MIL-I-27623C
AMENDMENT 3
6 JUNE 1986
SUPERSEDING
AMENDMENT 2
26 JUNE 1980

MILITARY SPECIFICATION

INDICATOR, ATTITUDE, REMOTE STANDBY, 2 INCH

This amendment forms a part of Military Specification MIL-I-27623C, dated 10 January 1972, and is approved for use by all Departments and Agencies of the Department of Defense.

FIGURE 2. Bank angle scale details lower location.

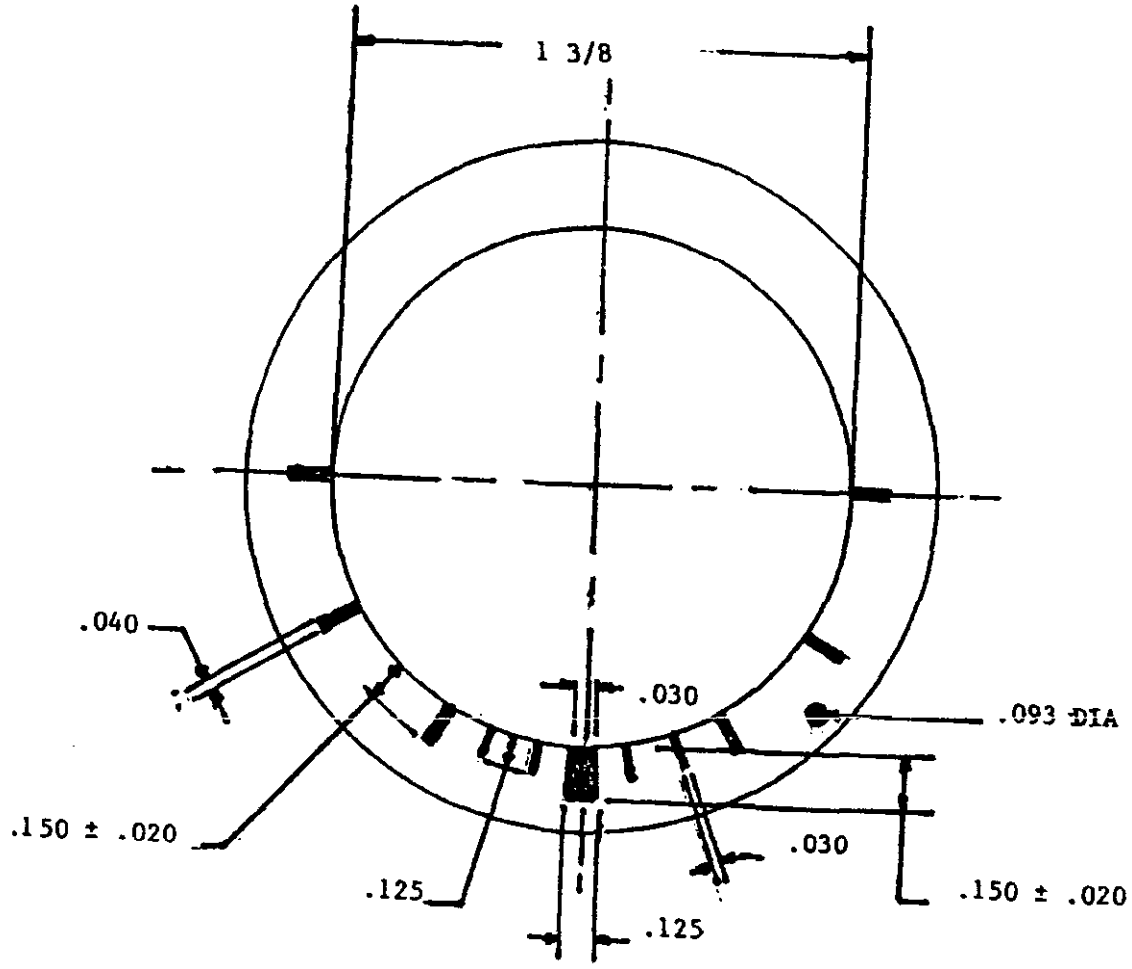
Figure 2: Delete existing figure 2 and substitute the new figure 2 shown as page 2 of this amendment.

MS27150-1 OR MS27150-3
(RED & WHITE LIGHTED)
OR MS27150-6 FOR AUGMENTED WHITE LIGHT
